VILLAGE OF HASTINGS-ON-HUDSON

Architectural Design Services: Village Hall

Addendum #2

Responses to Additional Questions

Exhibit A

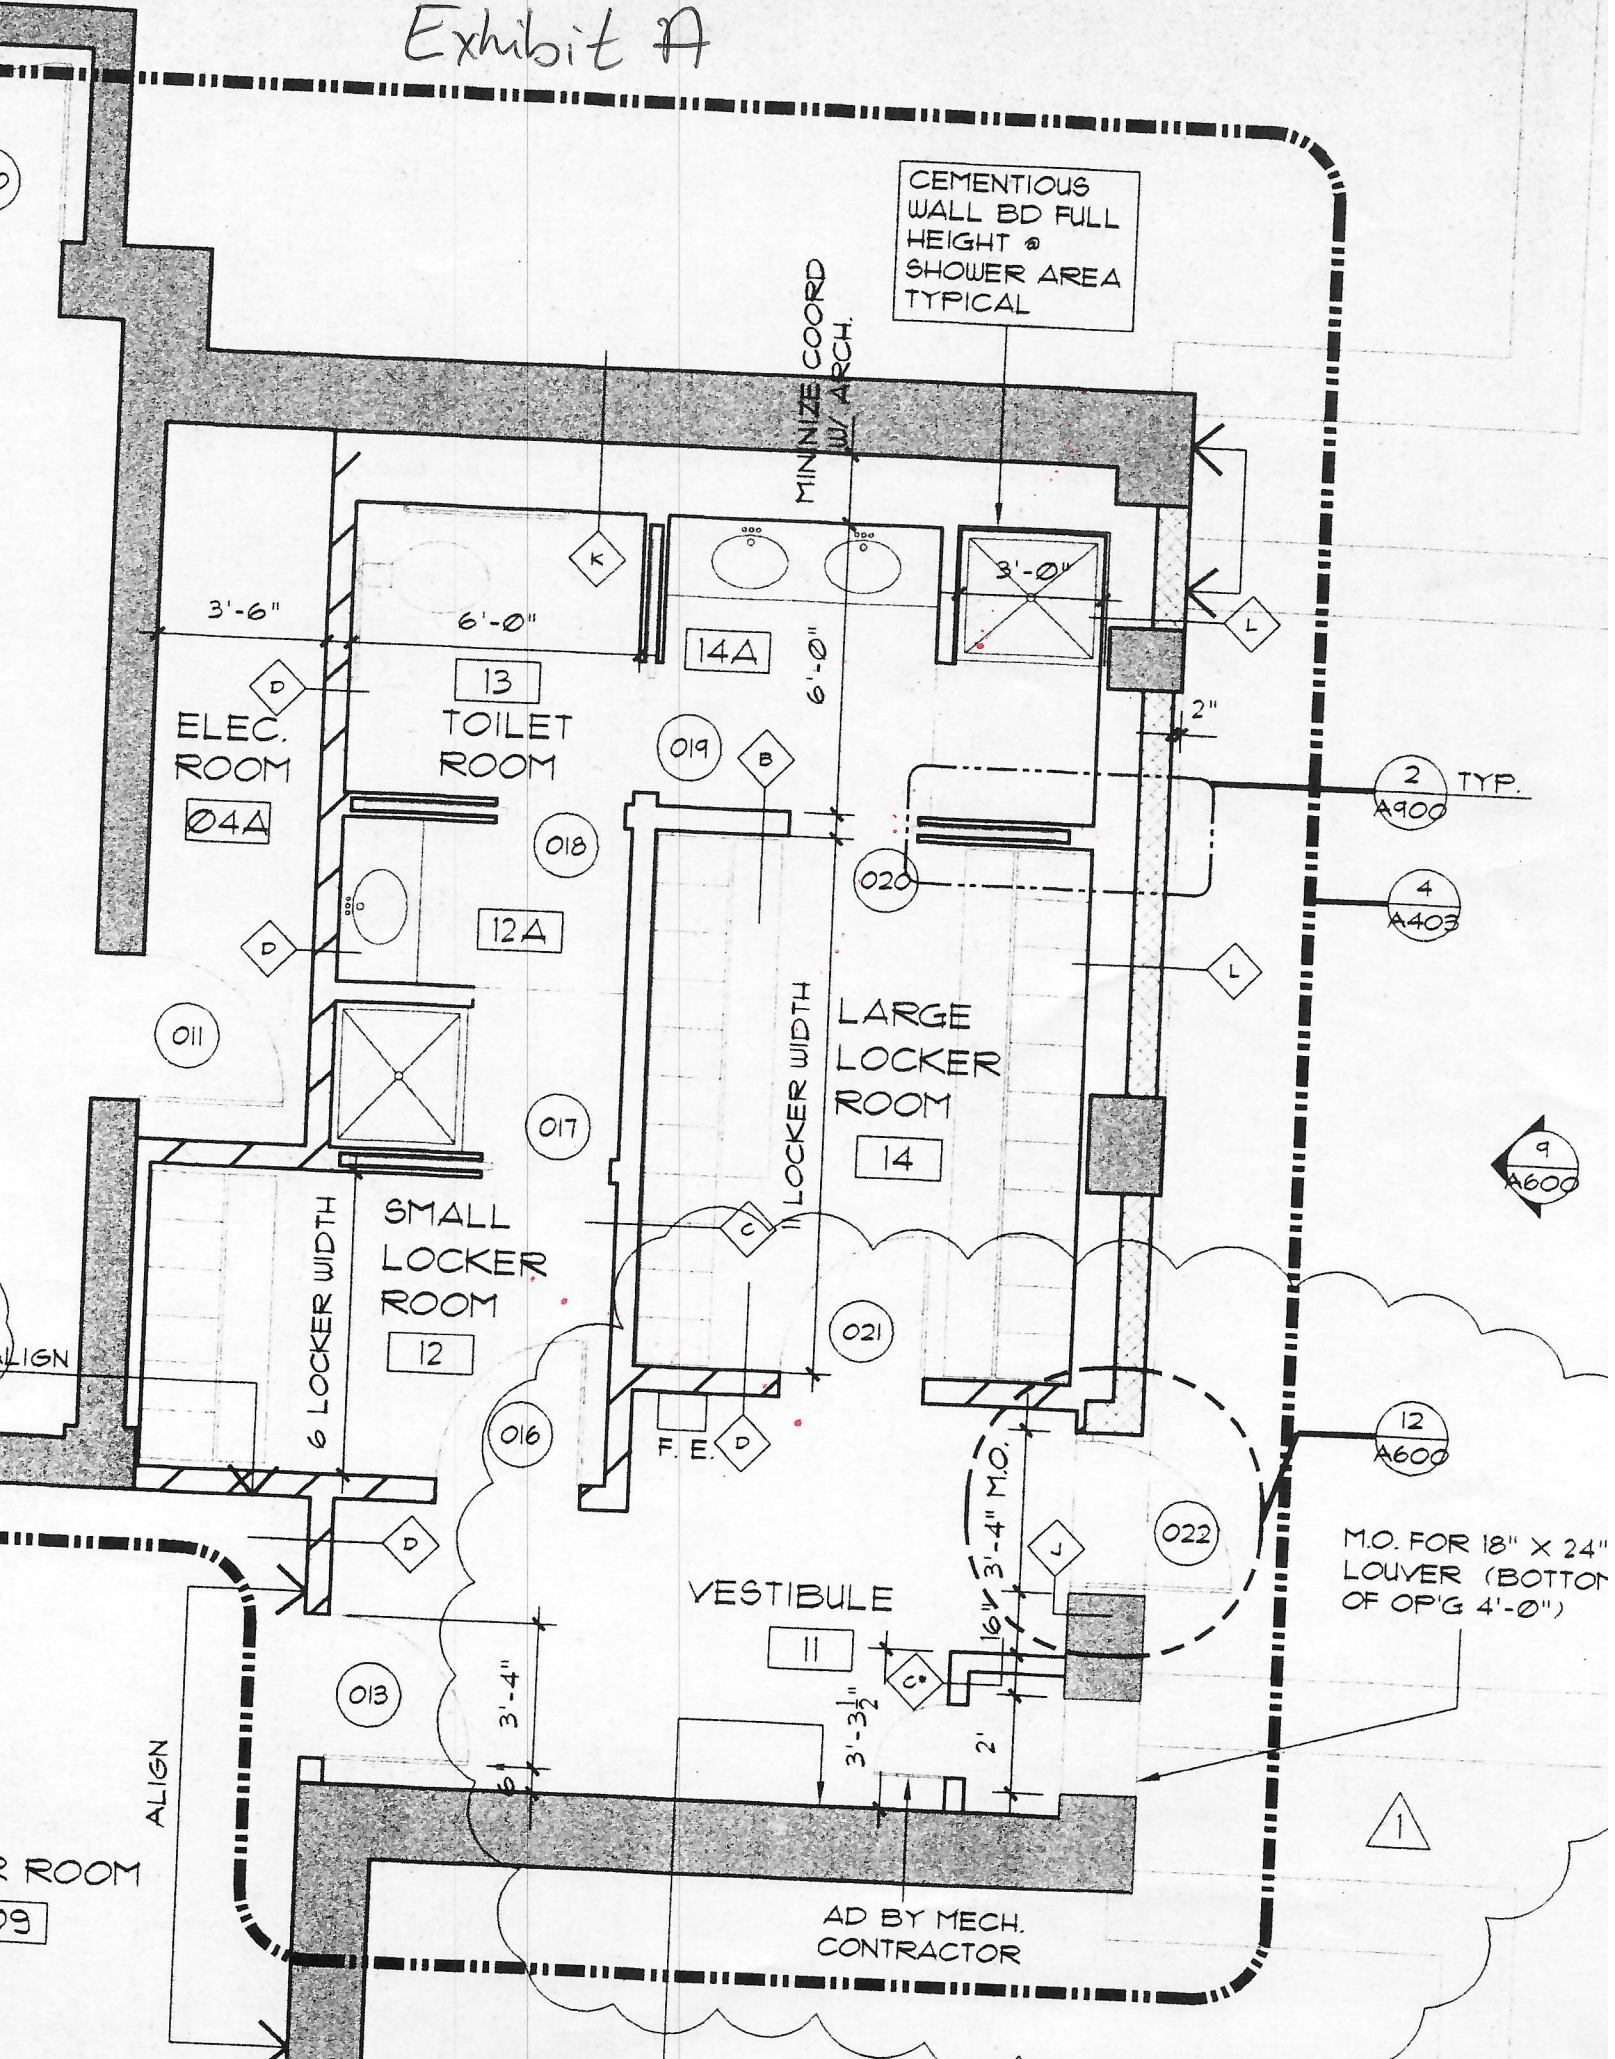
- No local landmark committees or planning boards associated with the interior or exterior planning for this facility.
- Please advise on scope [of HPD bathrooms and showers in the locker rooms], is there any existing floorplans that can be shared? What is the square foot of the existing bathroom and shower room and how many stalls/fixtures are being replaced?

- The existing floorplans are attached as Exhibit A. The existing bathroom is 138 square feet with 3 sinks, 1 toilet, and 2 showers.
- Please advise if the renovation only involves cosmetic/aesthetics upgrades i.e. (fixtures, tile, paint etc.) or if the modifications/renovations require upgrading electrical, mechanical systems.
